**RE: Request for Extension of Time
Sanitary Lagoon Investigation
Marathon Petroleum Company LP, Gallup Refinery
(dba Western Refining Southwest, Inc.)
EPA ID# NMD000333211**

**RE: APPROVAL WITH MODIFICATIONS
[REVISED] INVESTIGATION WORK PLAN
SANITARY LAGOON
WESTERN REFINING SOUTHWEST INC., GALLUP REFINERY
EPA ID # NMD000333211
HWB-WRG-18-004**

**RE: Response to Disapproval
[Revised] Investigation Work Plan Sanitary Lagoon October 2018
Marathon Petroleum Company LP, Gallup Refinery
(dba Western Refining Southwest Inc.)
EPA ID# NMD000333211
HWB-WRG-18-004**

RE: DISAPPROVAL
[REVISED] INVESTIGATION WORK PLAN SANITARY LAGOON
WESTERN REFINING SOUTHWEST INC., GALLUP REFINERY
EPA ID # NMD000333211
HWB-WRG-18-004

FIGURE 5
SANITARY LAGOON
PROPOSED SOIL SAMPLE LOCATIONS
BENEATH PIPELINE

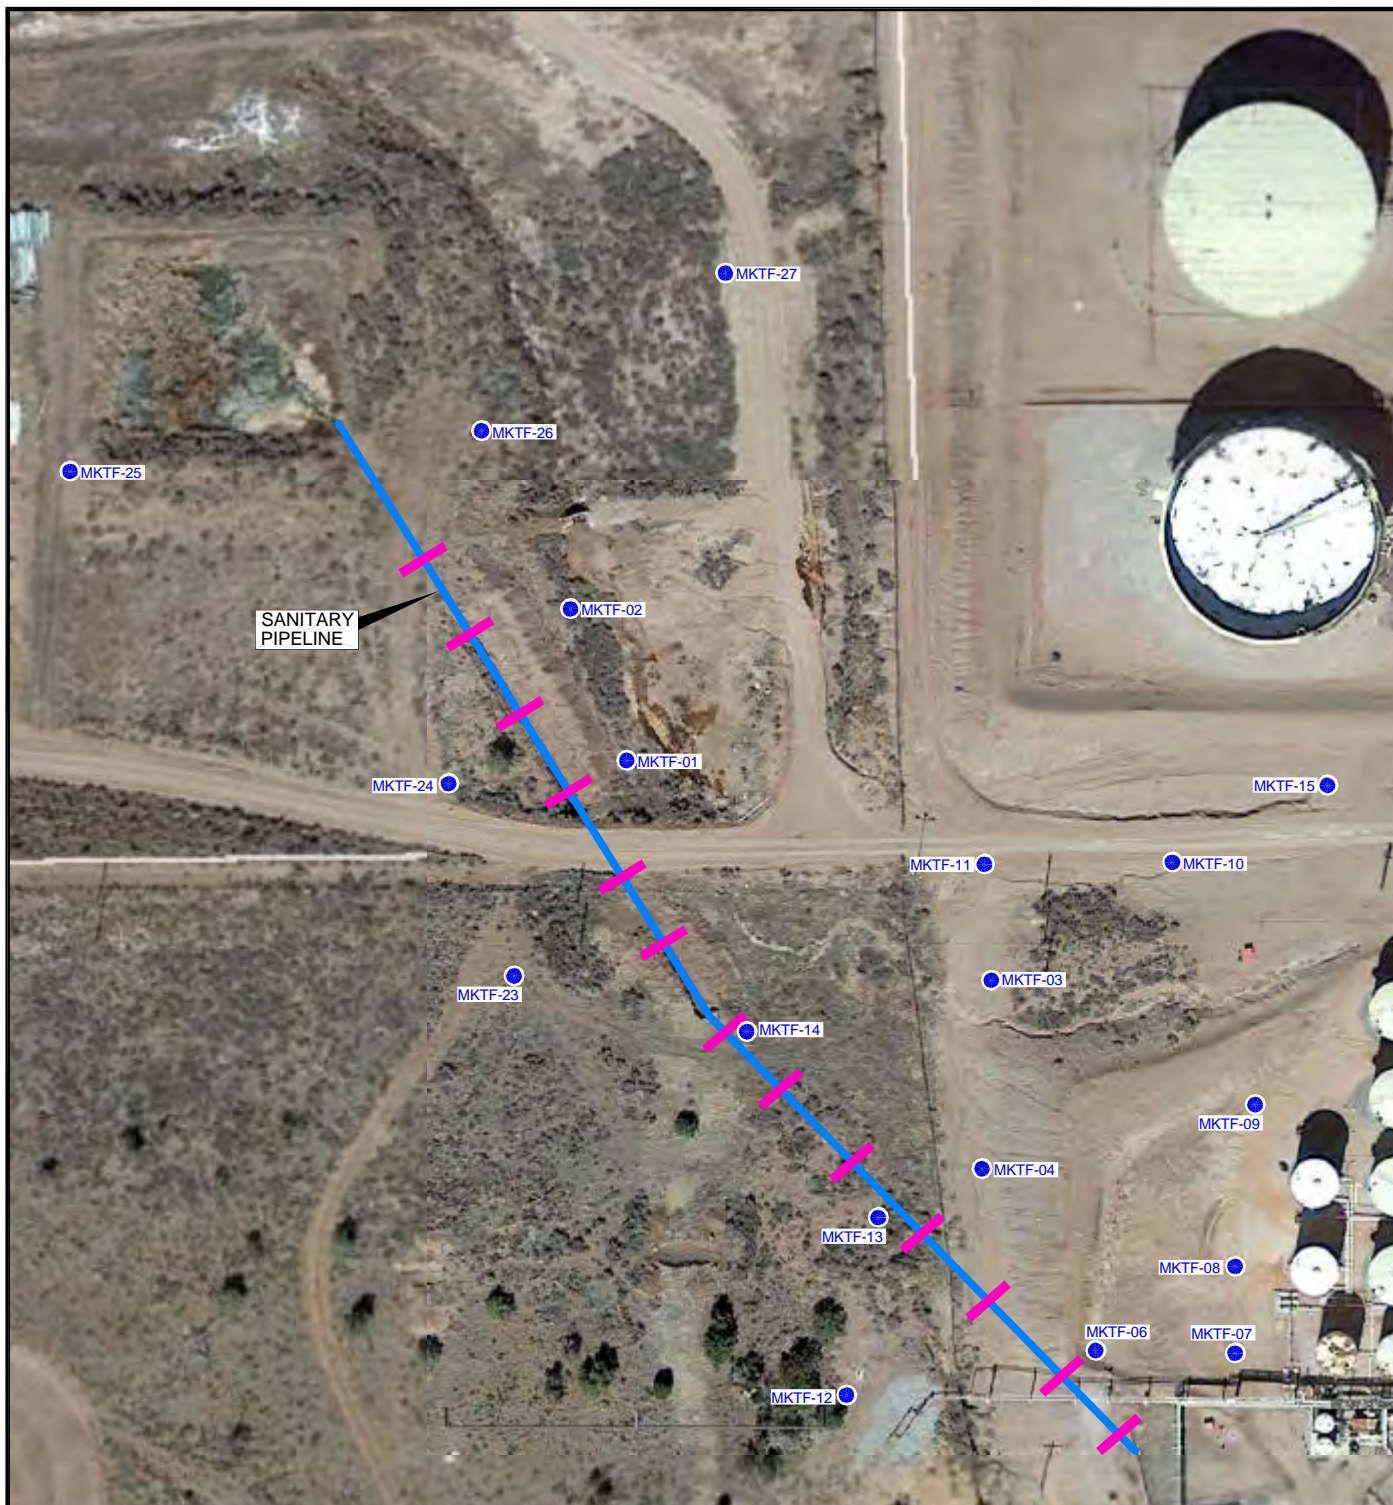
The Permittee's response to NMED's January 31, 2019 Disapproval (Disapproval) Comment 1 states, "[w]e reviewed Figure 5 Sanitary Lagoon Proposed Soil Boring Locations Adjacent to Pipeline and it does show the excavated area south of the lagoon. Possibly the comment was meant to refer to Figure 2, which has now been expanded to the south to include all of the area that was previously excavated south of the lagoon." The location of the excavated area is not clear from the provided figures. The boundary of the area(s) where the pipeline was previously excavated or exposed must clearly be marked in a figure in the investigation report.

Clarify the purpose of the trench. The revised Work Plan must provide the information regarding all activities performed at the site to date. Finally, Figure 5, *Sanitary Lagoon Proposed Soil Boring Locations Adjacent to Pipeline*, does not show the excavated area south of the lagoon. Provide a figure showing the excavated areas in the revised Work Plan.

In Section 4.1.3, *Drilling Activities*, the Permittee states, "[a] minimum of two exploratory trenches will be dug using a trackhoe to determine the depth of the pipeline." Figure 5 depicts the location of the proposed exploratory trenches approximately 500 feet to 700 feet southeast of the Sanitary Lagoon. The location and depth where the pipeline was buried northwest of the proposed exploratory trenches is speculative based on the extrapolated data since exploratory trenches are not proposed along the northwest section of the pipeline. Although installation of soil borings is proposed along the projected location of the pipeline, the proposed borings may not be located close enough to collect representative soil samples adjacent to the pipeline. The sampling must be more accurate. The exploratory trenches must be excavated from the outfall at the Sanitary Lagoon (or the southern end of the existing excavated trench, if the pipeline is exposed) to proposed boring location PL-6, every 50 feet. A maximum of 13 exploratory trenches must be excavated along the pipeline. In addition, propose to use a backhoe to collect soil samples along the exploratory trench wall beneath the pipeline, rather than to collect samples using soil borings. Furthermore, if the pipeline is damaged during the installation of the trenches, plug the outlet of the undamaged pipeline that is closest to the release points. Revise the Work Plan accordingly.

The pipeline that discharged into the Sanitary Lagoon was cut and then plugged with concrete on October 10, 2018. The NMED and OCD were notified of this activity in an email dated October 10, 2018. This email was addressed to Kristen VanHorn and Carl Chavez and included a photograph of the plugged line. The discussion in Section 2.1 (page 2-1) has been revised to reflect current site conditions and provide additional information, to the extent it is known, on the history of the area. We reviewed Figure 5 *Sanitary Lagoon Proposed Soil Boring Locations Adjacent to Pipeline* and it does show the excavated area south of the lagoon. Possibly the comment was meant to refer to Figure 2, which has now been expanded to the south to include all of the area that was previously excavated south of the lagoon.

Section 4.1.3 has been revised to remove the installation of soil borings along the pipeline, increase the number of trenches along the pipeline, and include collection of soil samples from the trenches beneath the pipeline. If the pipeline is damaged, then the pipeline will be repaired or plugged upstream of the damaged section.

FIGURE 5
SANITARY LAGOON
PROPOSED SOIL SAMPLE LOCATIONS
BENEATH PIPELINE

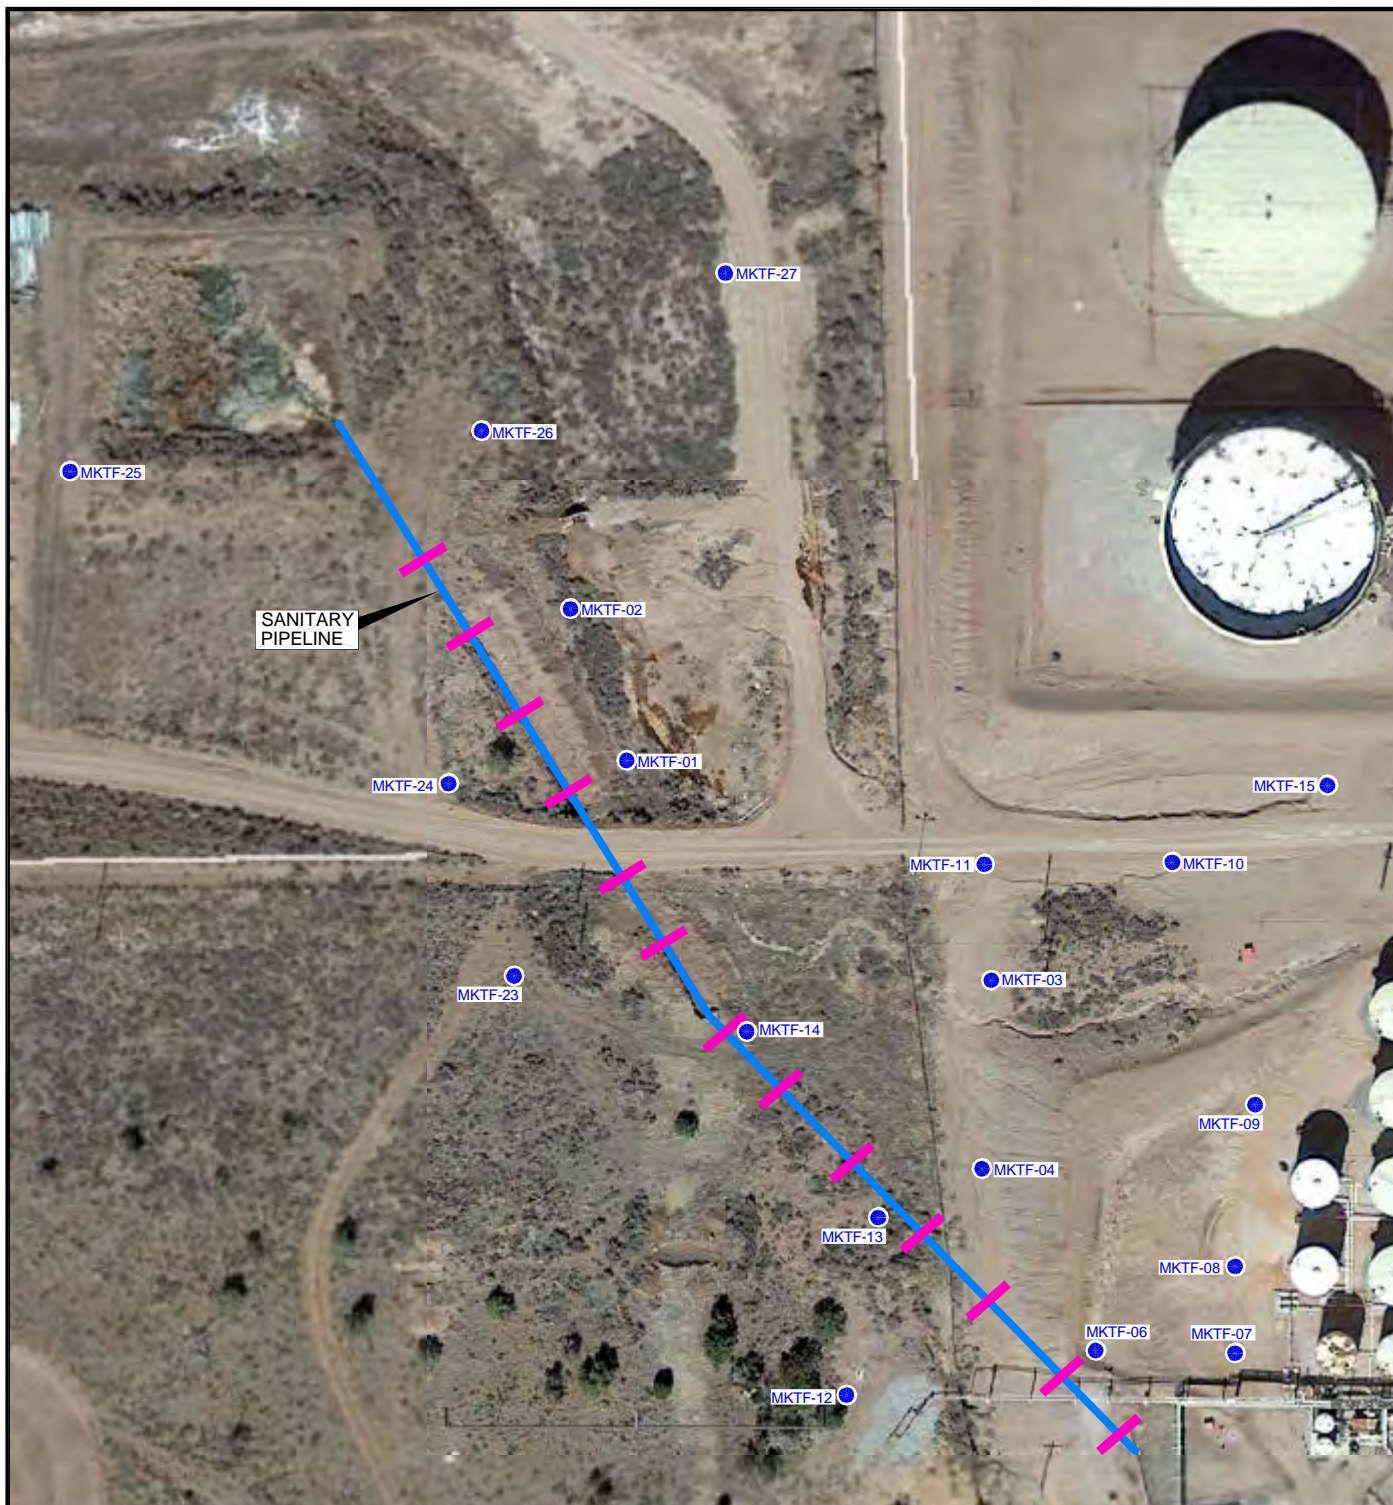
In Section 4.1.3, *Drilling Activities*, the Permittee states, "[a] minimum of two exploratory trenches will be dug using a trackhoe to determine the depth of the pipeline." Figure 5 depicts the location of the proposed exploratory trenches approximately 500 feet to 700 feet southeast of the Sanitary Lagoon. The location and depth where the pipeline was buried northwest of the proposed exploratory trenches is speculative based on the extrapolated data since exploratory trenches are not proposed along the northwest section of the pipeline. Although installation of soil borings is proposed along the projected location of the pipeline, the proposed borings may not be located close enough to collect representative soil samples adjacent to the pipeline. The sampling must be more accurate. The exploratory trenches must be excavated from the outfall at the Sanitary Lagoon (or the southern end of the existing excavated trench, if the pipeline is exposed) to proposed boring location PL-6, every 50 feet. A maximum of 13 exploratory trenches must be excavated along the pipeline. In addition, propose to use a backhoe to collect soil samples along the exploratory trench wall beneath the pipeline, rather than to collect samples using soil borings. Furthermore, if the pipeline is damaged during the installation of the trenches, plug the outlet of the undamaged pipeline that is closest to the release points. Revise the Work Plan accordingly.
